Fermoy Housing Development at Cork Rd, Fermoy Co. Cork

Stage 1 Road Safety Audit

January 2022

Figure 2.1.

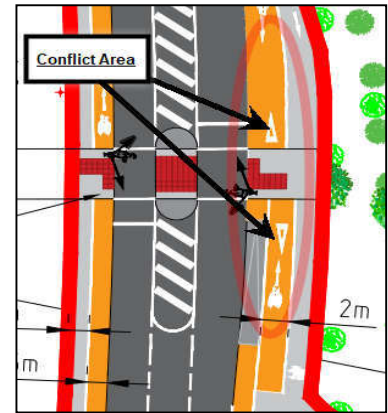
The proposed cycle lane as shown in Figure 2.1 could create confusion between pedestrian and cyclists at this locations. Failure to provide consistent and a streamlined design could lead to collisions and conflict between pedestrians and cyclist travelling in various directions. See Figure 2.1.

As there are no cycling facilities proposed as part of the development, the design team should consider providing a shared facility at this location.

2.1	Yes	Yes		
2.2	Yes	Yes		
2.3	Yes	Yes		
2.4	Yes	No	Proposed toucan crossing will be moved to the south of the development entrance junction and link into this length of footpath.	Yes

Figure 2.4

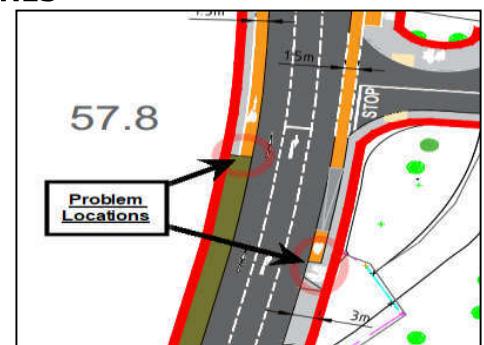
No details have been provided as to how cyclist will join and exit the proposed cyclelane to the south of the junction. Inadequate details at these locations could lead to collisions between cyclists and vehicles along R639. Refer to Figure 2.4

Provide connection details between the proposed cycle lanes and the R639

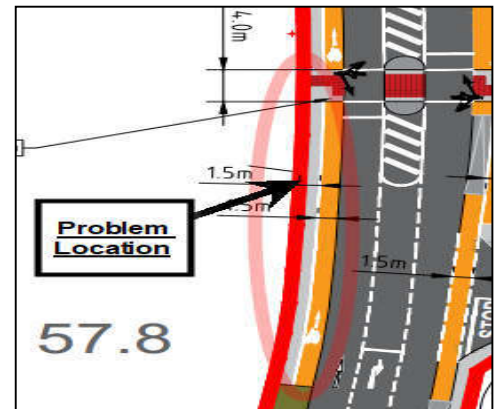
It is proposed to terminate the proposed footpath to the south of the proposed signalised pedestrian crossing on the western side of R639. This could lead to confusion for pedestrians and could cause collisions between pedestrians crossing the road at footpath end and vehicles travelling on the R639. Refer to Figure 2.5

The designed should look at the proposed termination point of the footpath.
